Statement of Response to LRD Opinion

**Prepared in Respect of a Planning
Application for a Large-Scale Residential
Development (LRD) at a Site of 1.621 Ha at
Galway Port, Galway City**

On Behalf of The Land Development Agency

September 2025

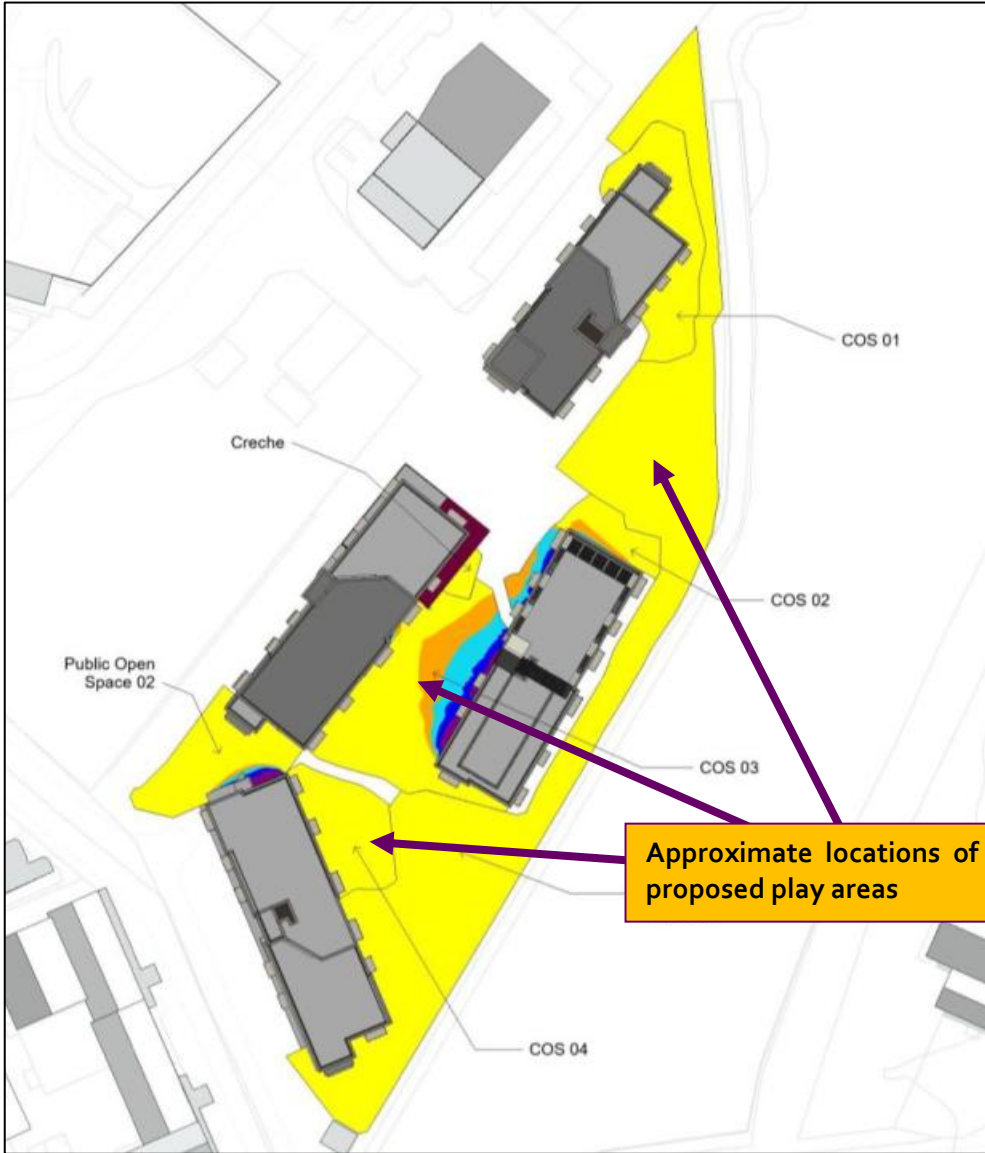
12 (Materiality)	<p>The concept of the materiality is unclear. In particular, the widespread use of brick material is somewhat alien in Galway City, of which it has no established tradition. Galway City's material palette is of render, stone and slate. This does not indicate that new developments should reflect the materials of the historic core, however, there is potential for the design to integrate itself with the city, and the city's sense of place through the appropriate use/interpretation of established forms, massing and materials. Therefore, a revised approach to the materiality of the building should be under taken in any future application that is to be submitted.</p>	<p>Response provided by ALTU:</p> <p><i>The Galway Inner Harbour Masterplan outlines the need for consistently high-quality, robust, well-detailed, and low-maintenance finishes that are appropriate for this exposed location and contribute to usable, liveable spaces.</i></p> <p><i>The materiality strategy for the proposed development has been carefully developed to balance contextual sensitivity, durability, and long-term performance, with particular consideration for Galway's coastal climate and the character of Lough Atalia Walk, as identified in the masterplan.</i></p> <p><i>While Galway's historic core is traditionally characterised by stone, render, and slate, the proposed use of brick offers a contemporary and durable reinterpretation of these materials. Brick has been selected for its resilience in coastal conditions, low maintenance needs, and appropriateness for cost-rental housing, providing a robust solution that addresses both environmental and economic considerations. Furthermore, as the subject site is primarily comprised of reclaimed land, and given the port area is largely without architectural merit at this location, there is an opportunity to define a new city quarter, with materials used as an important part of defining the site.</i></p>

TOPIC	LRD ITEM NO.	LRD REQUEST	RESPONSE
			<p>The development incorporates three complementary brick tones:</p> <ol style="list-style-type: none"> 1. Dark grey brick at ground level, grounding the buildings and referencing the industrial character of the adjacent docks and railway infrastructure 2. Primary brick tone 1: Light grey brick on upper levels, evoking the tone and grain of local limestone typical of Galway's civic architecture 3. Primary brick tone 2: Buff brick, used in combination with the light grey to introduce warmth and variation, referencing traditional rendered buildings and boundary walls in the surrounding urban fabric. <p>This palette brings material richness and variation while maintaining a cohesive architectural language across all four blocks. Additional detailing—such as brick banding, ribbed textures, and pressed metal elements—adds articulation and rhythm to the façades, contributing to a contemporary Galway identity that draws inspiration from, but does not replicate, the city's historic material tradition.</p> <p>The overall approach responds to the site's transitional location between the historic city centre and industrial docklands, offering a design that is modern, robust, and rooted in place.</p> <p>We welcome a planning condition requiring the submission of detailed material palettes, colour samples, and finish specifications, and will work closely with the Council to ensure that all materials selected are high quality, weather-resistant, and appropriate to Galway's evolving urban context.</p> <p>Refer to Architectural Design Statement 5.13 Materiality Strategy & 5.14 Materiality Palette</p>

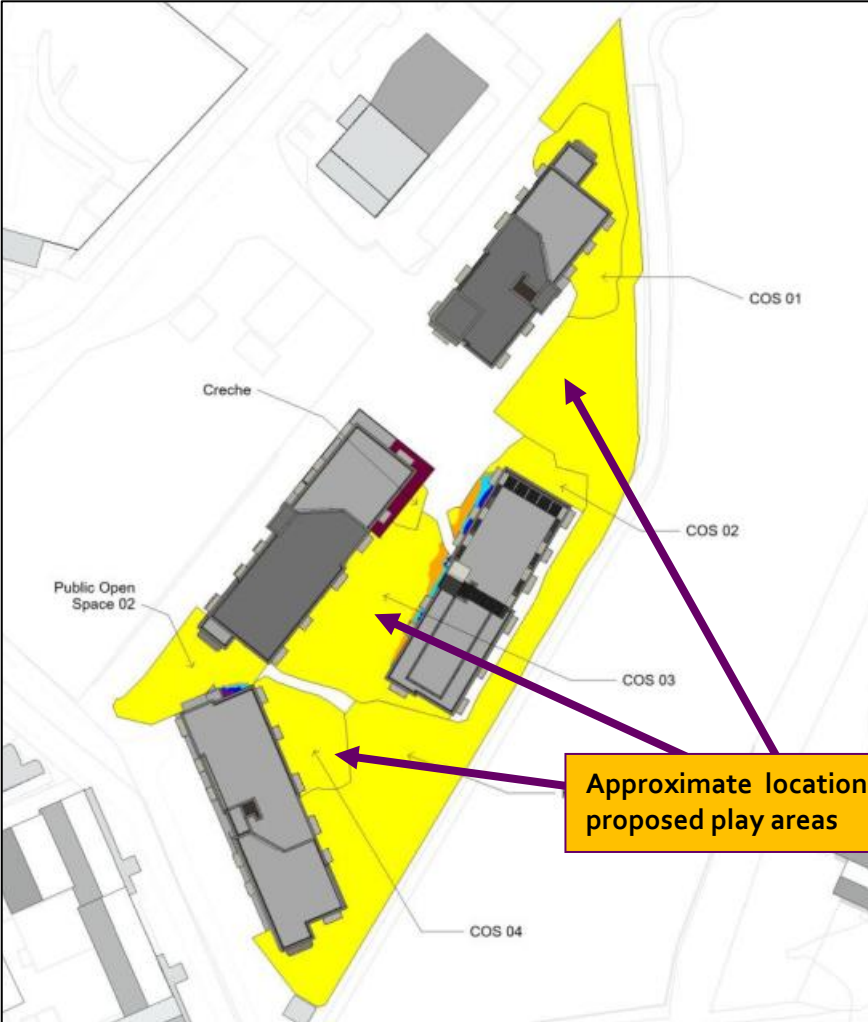
15 (Residential Amenity)	It is noted that the separation distances as per SPPR 1 of Sustainable Residential Development and Compact Settlements Guidelines for Planning Authorities (DHLGH January 2024) is not achieved between Blocks A and B	Following the LRD Meeting and receipt of the <i>LRD Opinion</i> , revisions were made to the design and layout of the proposed development. These have resulted in the following separations distances in the development that is now the subject of this Planning Application:

TOPIC	LRD ITEM NO.	LRD REQUEST	RESPONSE
		and Blocks C and D. This matter should be addressed in any forthcoming application.	<ul style="list-style-type: none"> Blocks A and B do not contain directly opposing habitable façades; therefore, they are not subject to the minimum separation requirement. Blocks A and C are 29.7 m apart at their closest point. Blocks B and C are 17.5 m apart at their closest point, with their angles relative to each such that this separation increases to 23.4 m. Blocks B and D are 29 m apart at their closest point. Blocks B and C are 23.1 m apart, but are entirely offset from each other, such that they do not have opposing elevations. Blocks A and D do not interface with each other. <p>Therefore, the proposed development complies with SPPR 1.</p>
	16 (Residential Amenity)	Drawings/visuals, photomontages and streetscape elevations of key viewpoints of the site from the surrounding area displaying its contextual setting, public realm attributes, layout, boundary treatment, and amenity impact are required.	<p>Additional CGIs and visualisations have been prepared by ALTU and Model Works to illustrate the proposal's contextual setting, streetscape character, and public realm impact. These include key viewpoints from the junction of the primary and secondary streets on Dock Road and from the Lough Atalia Road junction, providing a clear understanding of the development's urban interface and architectural form.</p> <p>These images have been used in the preparation of the 'Landscape and Visual Assessment' Chapter of the EIAR.</p> <p>Details of boundary treatments, surface materials, and public realm features are addressed in the accompanying landscape design drawings and reports, which form part of the overall planning submission.</p>

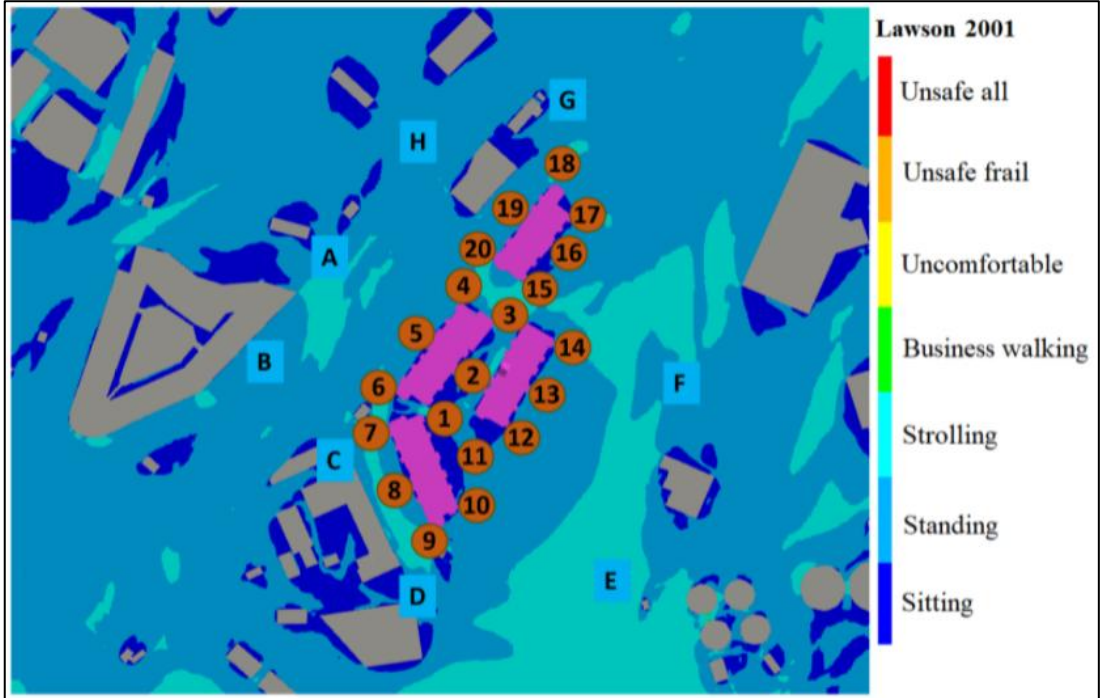
19 (Architectural Conservation)	It is considered that the proposed development as presented in the documents submitted for the LRD Meeting will have a significant impact on views out of the Forthill Cemetery, a protected structure. The massing of the blocks is considered jarring, due to the widespread use of flat roofs, and significant areas of blank facades. As such, the proposed form is not considered to relate to the character of Galway City, or its docklands location; noting that other adjacent developments have addressed their setting in a more successful manner. A revision of the massing, and treatment of roofscape in particular	<p>Response provided by JCA:</p> <p><i>The likely impact of the proposed development on views out of (and on the setting of) Forthill Cemetery have been assessed in both Chapters 11 and 14 of the EIAR. No significant negative impacts have been identified.</i></p> <p><i>The design team have taken account of the observations made by Galway City Council during the LRD consultation process. The massing and treatment of the roofscape has been altered to lessen the impact on</i></p>

TOPIC	LRD ITEM NO.	LRD REQUEST	RESPONSE
		should be addressed in order to lessen the impact on Forthill Cemetery and views of the City in general. Updated visual imagery should also be provided to support any application.	<p><i>Forthill Cemetery and views of the city in general. Updated visual imagery has been prepared by the Model Works and is available for detailed review under separate, enclosed cover.</i></p> <p><i>Given the site's sensitive location adjacent to Forthill Cemetery, a protected structure, the design has evolved with a strong emphasis on contextual sensitivity, visual impact, and architectural refinement. As the first development within the Galway Harbour Regeneration Area, the scheme plays a key role in shaping future phases, including new streets, public spaces, and the waterfront edge.</i></p> <p><i>With 360-degree visibility, the buildings are designed to perform well in both close-up and distant views. The architecture carefully balances the cost-rental brief with a refined massing strategy, aiming to reduce visual impact while contributing meaningfully to the public realm.</i></p> <p><i>Key design measures include:</i></p> <p><i>Chamfered upper levels and an articulated roofline that help break down the perceived bulk of the blocks—particularly from elevated viewpoints such as Forthill Cemetery—while contributing to a more dynamic and varied skyline.</i></p> <p><i>A diverse and carefully detailed façade treatment, incorporating ribbed and protruding brickwork, button bricks, horizontal stack bonding, and stone banding, adds depth, rhythm, and texture to each elevation, enhancing the architectural expression across the scheme.</i></p> <p><i>Lower parapets with metal cappings, combined with recessed and screened rooftop plant, minimise the visual impact of roof-level services and reduce the dominance of flat roof profiles.</i></p> <p><i>Together, these strategies create a layered, well-articulated, and visually responsive development that respects its context, contributes positively to the evolving Galway cityscape, and responds sensitively to views from protected structures such as Forthill Cemetery.</i></p>
